ZONING SITE PLAN
FOR:

3711 ROBINSON ROAD
LAND LOT 887
16TH DISTRICT AND SECTION
COBB COUNTY, GEORGIA

Z-44
(2013)

ZONING COMMENTS: **Staff Member Responsible:** Jason A. Campbell

Z-44

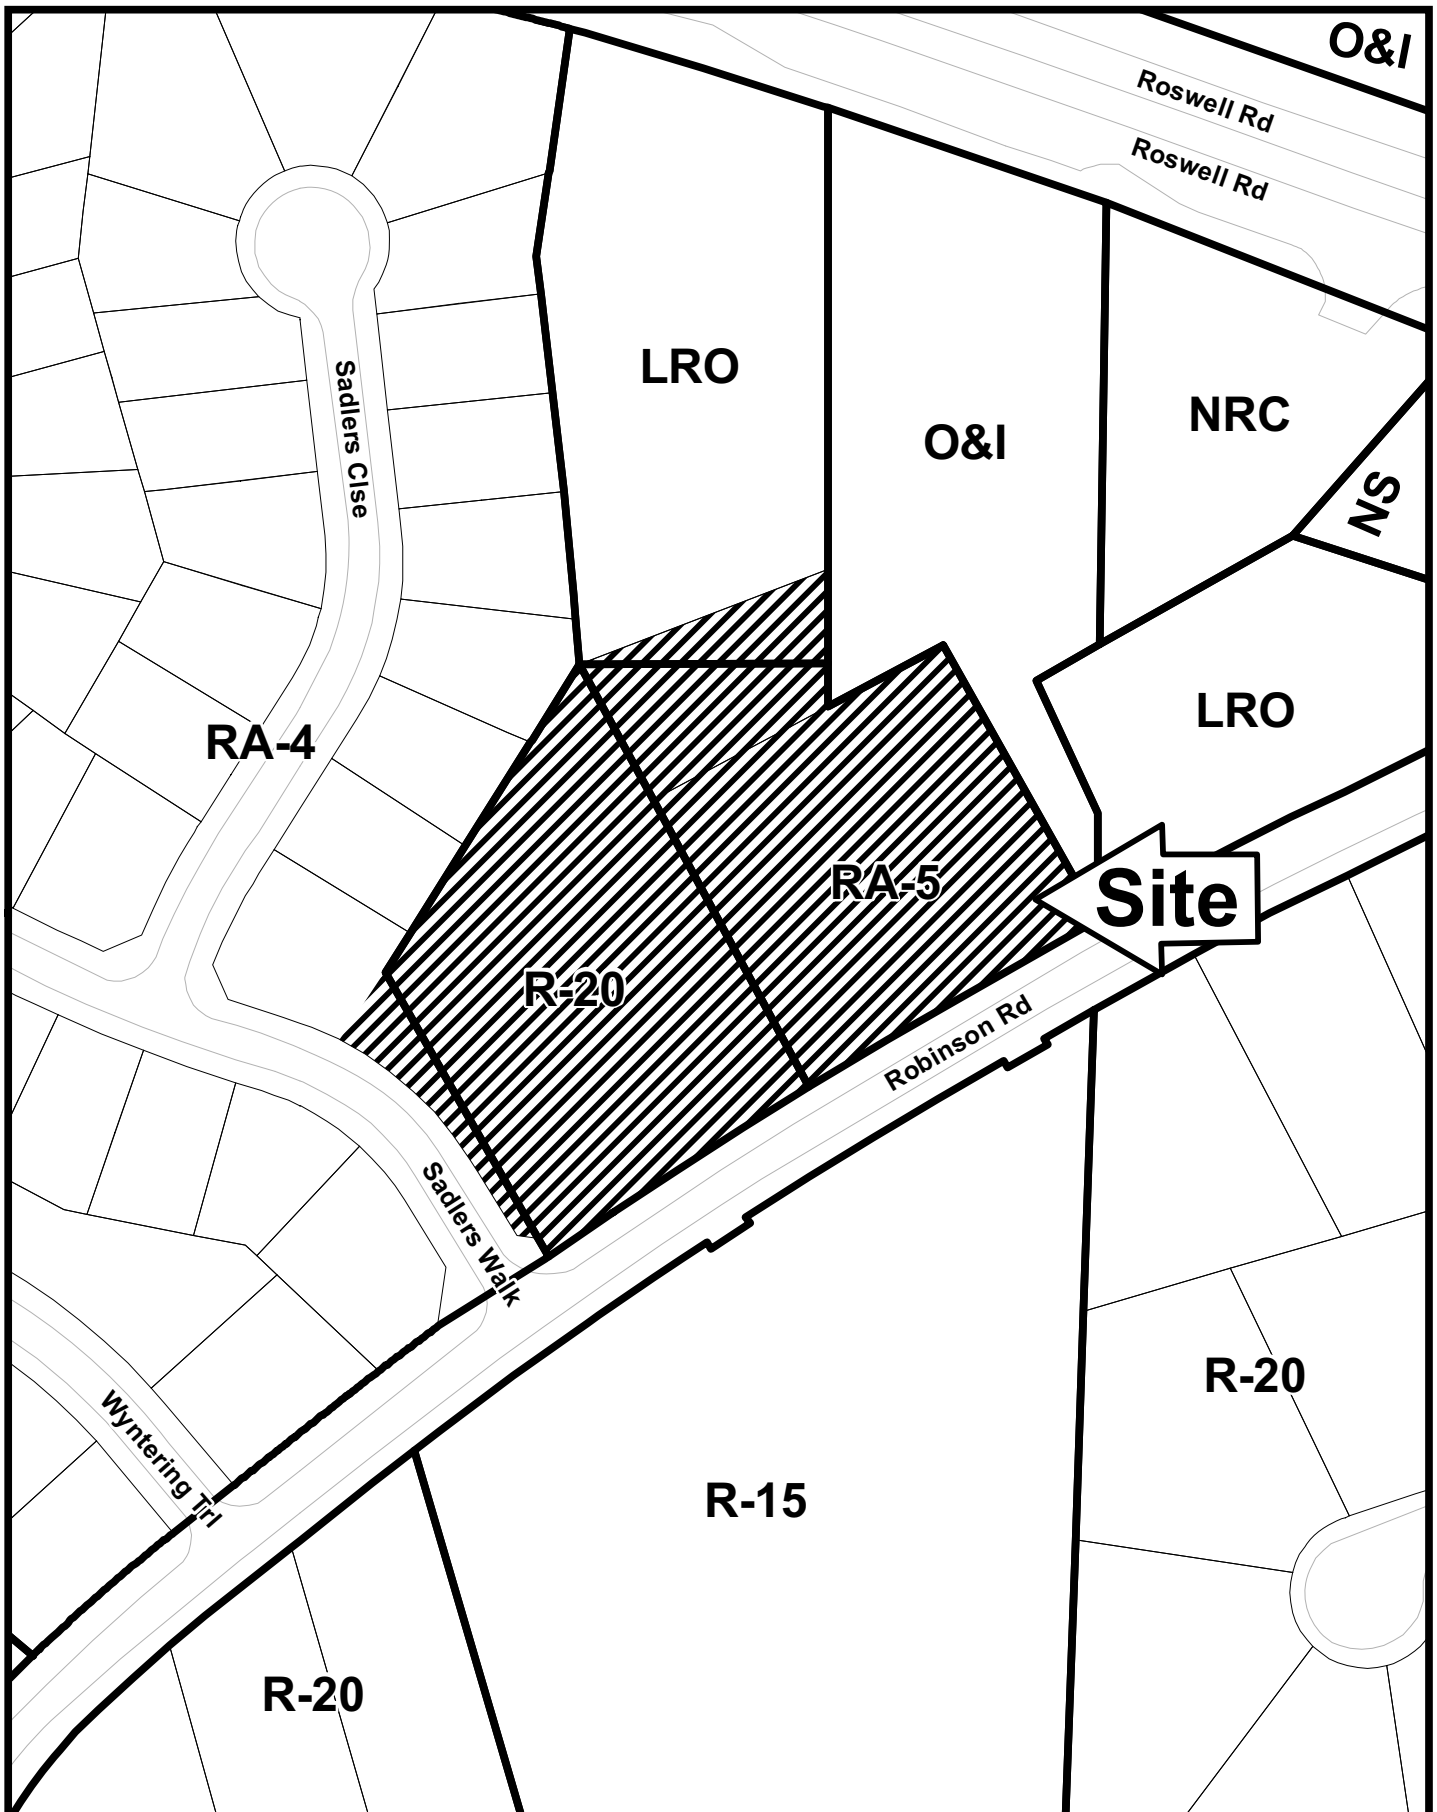
Applicant is requesting to be zoned to the site plan submitted to the Zoning Division on May 31, 2013, which indicates that variances are needed for the rear setbacks for lots 1 through 5 from the required 40 feet for exterior lots to 20 feet; and for lots 6-11 from the required 30 feet for interior lots to 20 feet. Also, a variance will be required for the major side setbacks (along Robinson Road) to waive the minimum requirement of 20 feet to 10 feet.

GUEST PARKING: When projects contemplate less than 20 foot separation between units, guest parking shall be provided or the streets shall be labeled as a fire lane.

Robinson Road is classified as a major collector and according to the available information the existing right-of-way does not meet the minimum requirements for this classification.

Recommend applicant verify that minimum intersection sight distance is available for Robinson Road access and if it is not, implement remedial measures, subject to the Department's approval, to achieve the minimum requirement of 390'.

Recommend removing and closing driveway apron along Robinson Road frontage that development renders unnecessary.

Recommend replacing disturbed curb, gutter, and sidewalk along the Robinson Road and Sadlers Walk frontages.

Recommend curb and gutter along both sides and sidewalk along one side of proposed development roadway.

Recommend applicant consider entering into a development agreement pursuant of O.C.G.A. 36-71-13 for dedication of the following system improvements to mitigate traffic concerns: a) donation of right-of-way on the north side of Robinson Road, a minimum of 30' from the roadway centerline and an additional 5' of roadway easement from the proposed right-of-way.

- Site plan submitted to the Zoning Division on May 31, 2013, with the District Commissioner approving minor modifications;
- Fire Department comments and recommendations;
- Water and Sewer comments and recommendations;
- Stormwater Management Division comments and recommendations;
- DOT comments and recommendations; and
- Owner/developer to enter into a Development Agreement pursuant to O.C.G.A. §36-71-13 for dedication of system improvements to mitigate traffic concerns.
